Work Order ID 94663

Item Name: Basket Hoop

DESIGN #	DRAWN BY CP	DART AEROSPACE LTD HAWKESBURY, ONTARIO, CANADA	
CHECKED #	APPROVED #	DRAWING NO. D3166	REV. A SHEET 1 OF 1
DATE 02.07.10		TITLE BASKET HOOP	SCALE NTS
A	02.07.10	NEW ISSUE	
A1	04.04.08	38+/-1 WAS 36.0

DRAWING NO. D3166	TITLE BASKET HOOP	REV A1	DART AEROSPACE LTD ENGINEERING ORDER		D.E.O. NO. D3166-A-2	SHEET NO. 1 OF 1	SCALE NTS
DRAWN AJS	CHECKED <i>[Signature]</i>	MFG. APPR. <i>[Signature]</i>	APPROVED <i>[Signature]</i>		DE APPR. <i>[Signature]</i>		
DATE 08.12.11	DATE 08.12.15	DATE 08/12/15	DATE 08/12/16		DATE 08.12.16

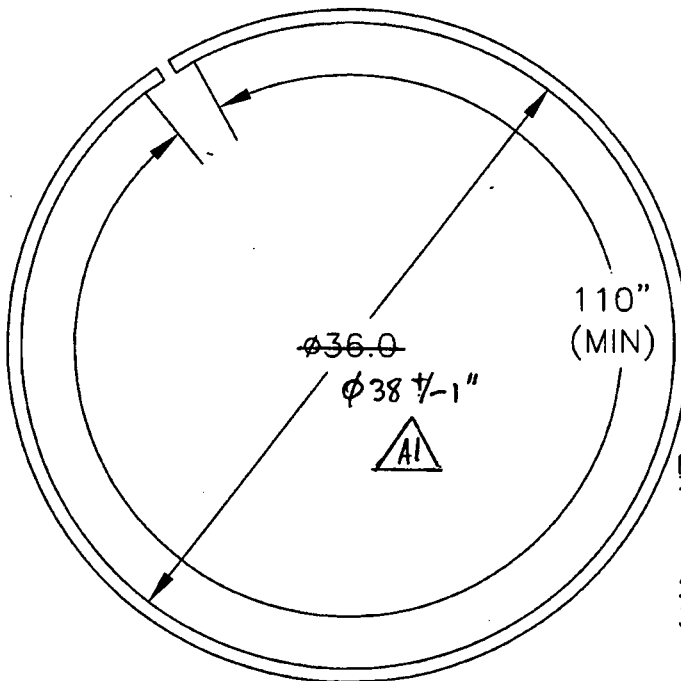
1) MODIFY MATERIAL NOTE FOR D3166-1 AS SHOWN:

WAS:

1) MATERIAL: AISI 304/316 SS SQUARE TUBING,
0.75" x 0.75" x 0.063 WALL, 60.00" LONG
(REF DART SPEC. M304TS0.750W.063)

2) MODIFY MATERIAL NOTE FOR D3166-3 AS SHOWN:

WAS:

1) MATERIAL: AISI 304/316 SS SQUARE TUBING,
0.75" x 0.75" x 0.063 WALL, 120.00" LONG
(REF DART SPEC. M304TS0.750W.063)

REASON: SEE PAR 08-005

IS:

1) MATERIAL: AISI 304/316 SS, 3/4 X 3/4 X 0.065 WALL SQUARE TUBING,
60.00" LONG
REF. DART SPEC M304TS0.750W.065

IS:

1) MATERIAL: AISI 304/316 SS, 3/4 X 3/4 X 0.065 WALL SQUARE TUBING,
120.00" LONG
REF. DART SPEC M304TS0.750W.065
